From: [Planning Portal - Department of Planning and Environment](#)
To: [DPE PS ePlanning Exhibitions Mailbox](#)
Cc: [DPE Riverstone East - Stage 3 Mailbox](#)
Subject: Webform submission from: Riverstone East Stage 3 Draft Indicative Layout Plan
Date: Wednesday, 13 March 2024 11:22:08 AM
Attachments: [wslhd-ce-letter-riverstone-east-stage-3-precinct-exhibition-2024.pdf](#)

Comments: Riverstone East Stage 3 – draft precinct plan

Blacktown City Council submission on Stage 3 Riverstone East Integrated Layout Plan and Draft Development Control Plan

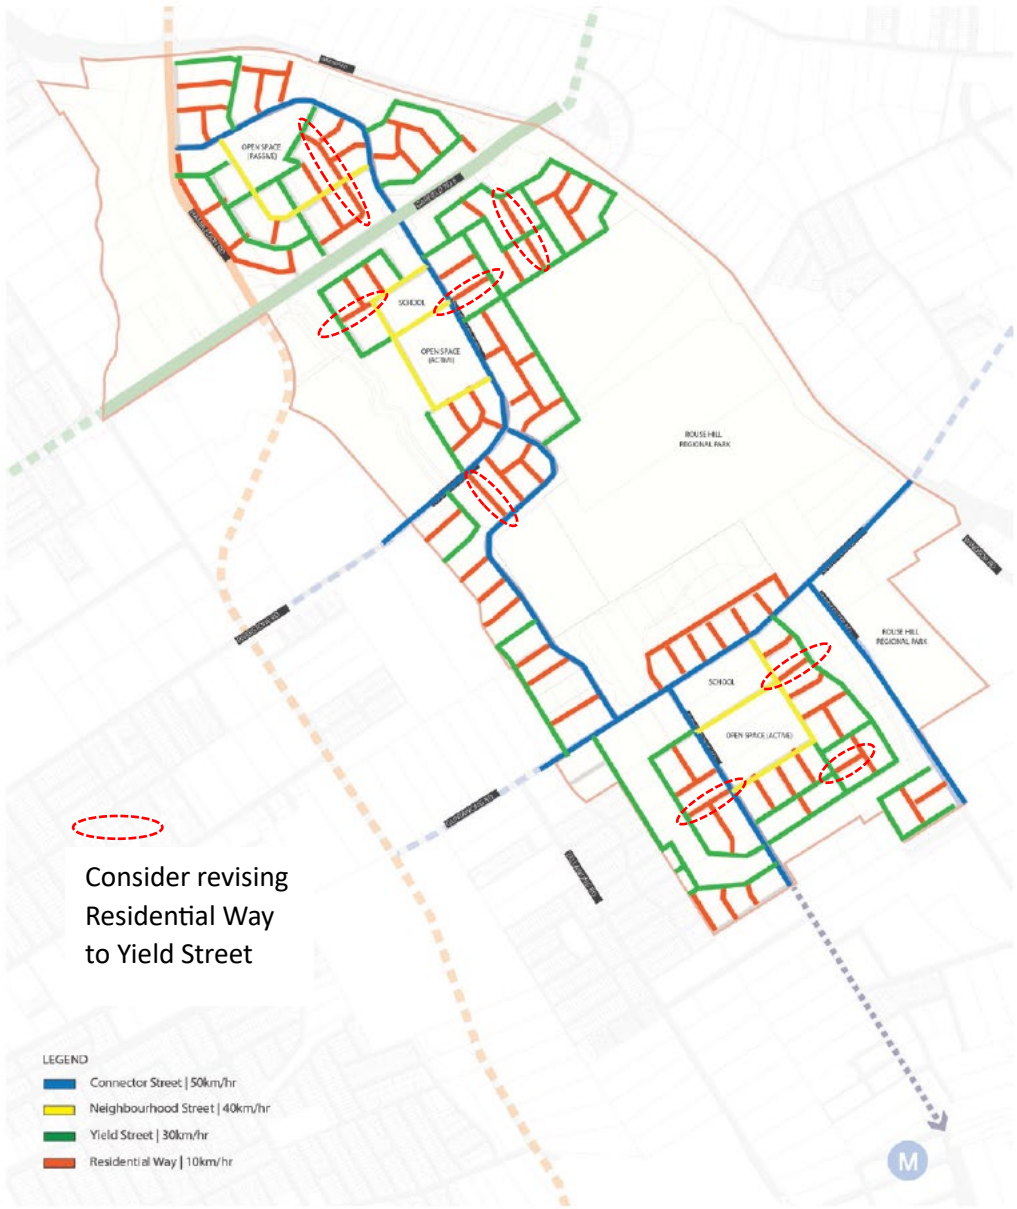
4.3 Linden Street Bella Vista is a Residential Way, not a Yield Street. The carriageway is a consistent ~5.5m. Suggest using some another ‘suburban context’ photo for Yield Street.

4.4 Eckersley Way Moorebank is a very atypical subdivision use of a Residential Way as it only has one side with lot frontages and the other is lot side boundaries. Suggest the Residential Way ‘suburban context’ example photo be revised. Suggest the Linden Way Bella Vista, or Bransby Place Mt Annan.

Land reservation acquisition map

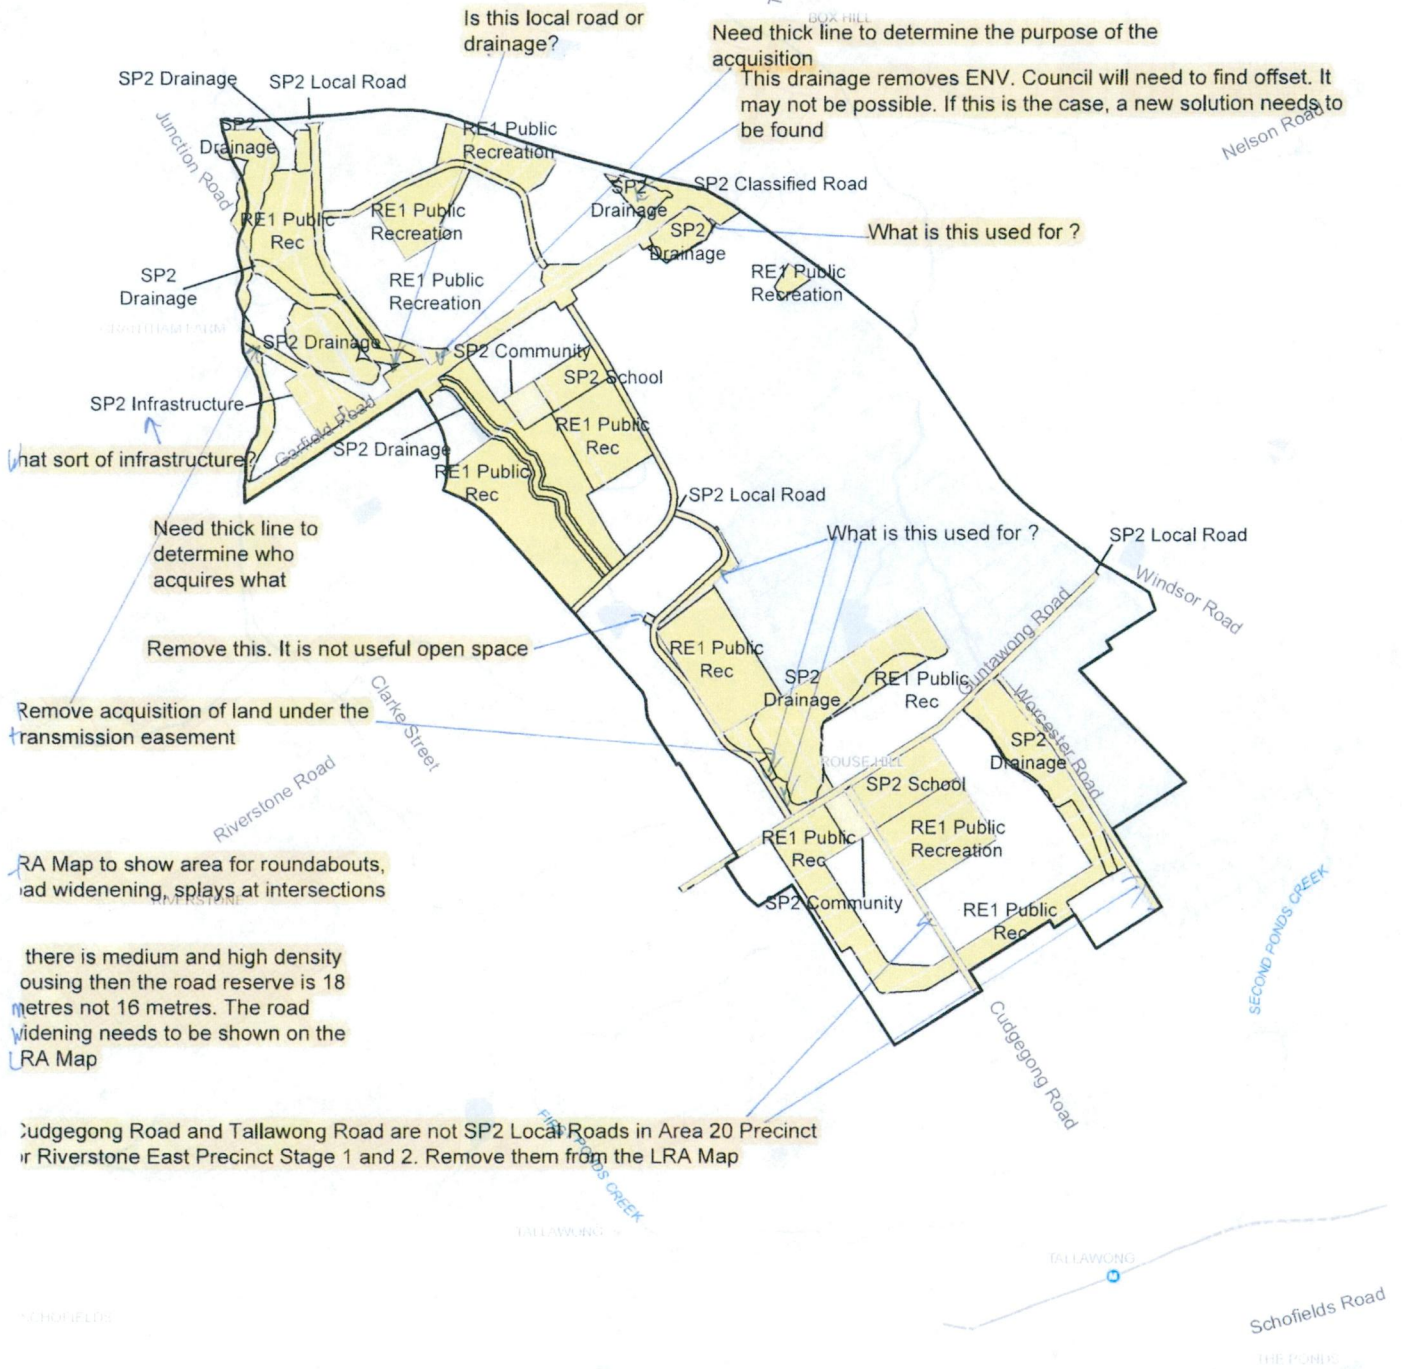
RE1 Public Recreation- spell out in full

SP2 insert "Local" Road

SP2 Community insert "facility"

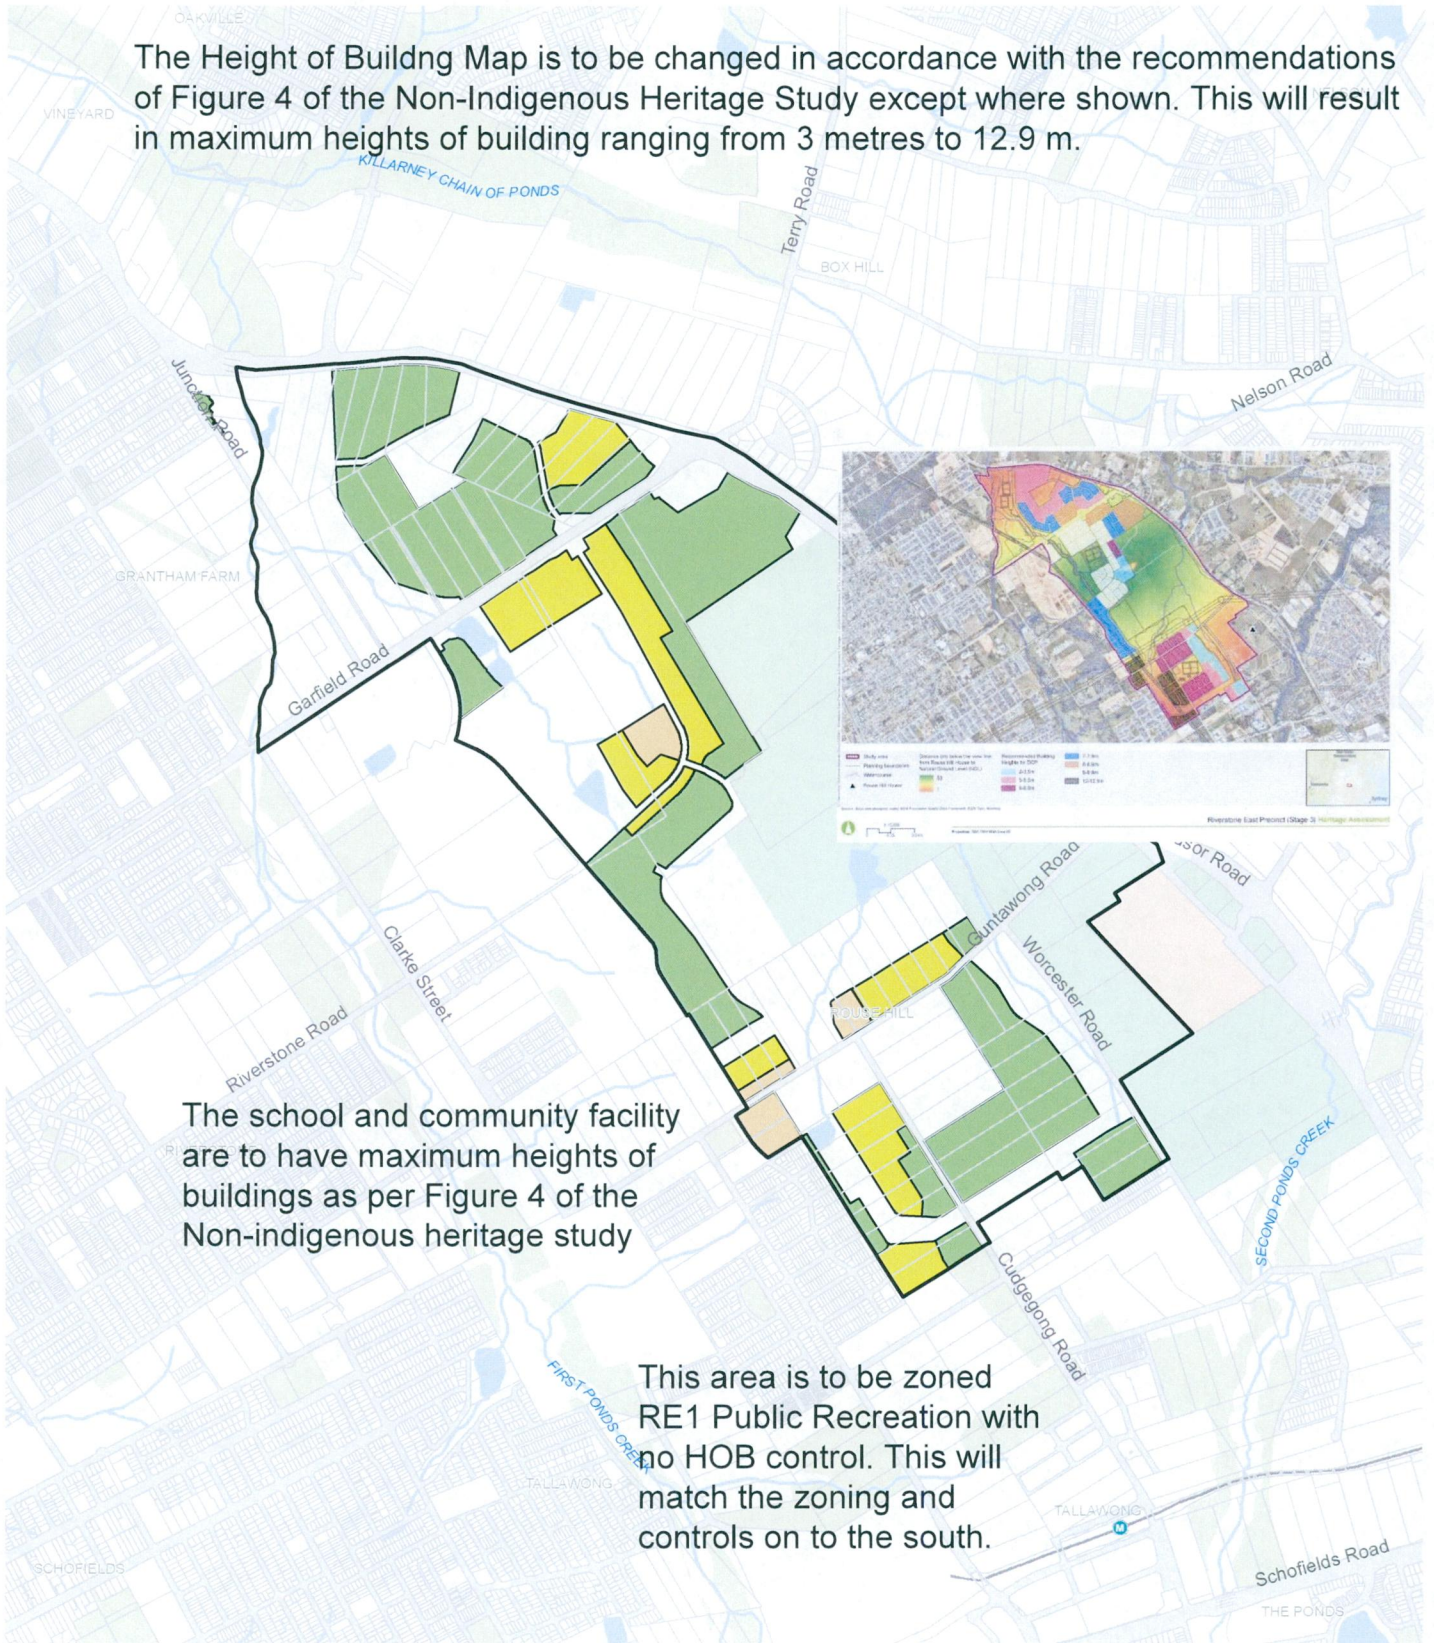
The Height of Building Map is to be changed in accordance with the recommendations of Figure 4 of the Non-Indigenous Heritage Study except where shown. This will result in maximum heights of building ranging from 3 metres to 12.9 m.

The school and community facility are to have maximum heights of buildings as per Figure 4 of the Non-indigenous heritage study

Change legend to reflect Figure 4

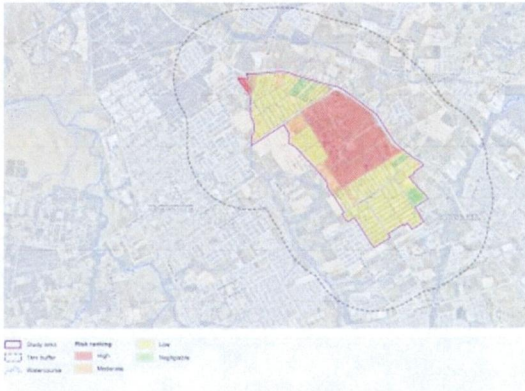
3.2.4 Indigenous and non-Indigenous heritage (Page 17)	<p>Is there a map where this would apply? How will the walking tracks be funded? Who will be responsible for the planning, approval, construction and maintenance?</p> <p>Will the local first nations people be involved in the process</p> <p>Where are the controls for the Tyburn Monastery? Where is the curtilage on the map for each item?</p>
Rummary House Remains (Page 17)	<p>Figure 4 is the Flood Prone Land Map in this DCP. Is this what you mean? If not, please state the name of the figure.</p> <p>Where is the map? How is reflected in the HOB Map</p> <p>Is it discussed in the Urban Design Report?</p>
Box Hill Stable Remains	<p>Which former house is this?</p> <p>Where are the view lines?</p>

DCP Section	Comment
	Where are the height controls
Windsor Road	Figure 7 is a salinity map. It is doubted whether is map is the one that applies here. Put the full name of the Figure.
Rouse Hill Curtilage Extension	Figure 4 is the Flood Prone Map. Is it Figure 8 which should be mentioned here?
Figure 8 – Non-Indigenous Heritage (Page 19)	Heritage items? Isn't this proposed heritage items? Tyburn monastery is not a heritage item at the moment. The curtilage of Tyburn monastery is not shown. It needs to be shown.

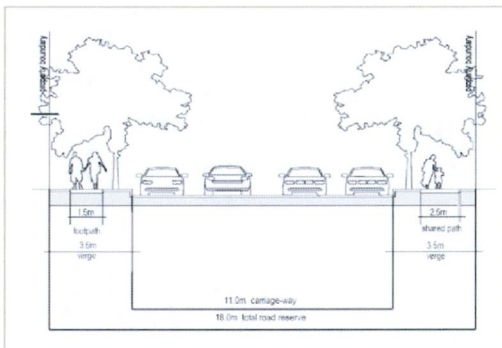
4.2 Built Form Design Controls (Page 28)	Where are these controls from?

DCP Section	Comment
Table 3 (Page 28)	This rather wordy, It is not clear what it means, Try re-phrasing it.
Page 29	This is rather wordy. Try re-phrasing it
	Where is the control that requires trees to be provide on future lots?
	Is there a specific requirement for planning trees in the front setback?
	Meaningful to whom. The meaning needs to be more specific?
Page 30	<p>We need to set verge widths to be consistent. These must be wide enough to fit more trees in to achieve the urban cooling objectives. Please provide evidence of how the current designs would achieve the urban cooling objectives. Generally we should be consistent with Western Sydney Panning Partnership work. Amend typical road cross sections (section 4.3) as these only show 1 tree location on each side of the road.</p> <p>Show locations of where private trees can and should be planted as well.</p>
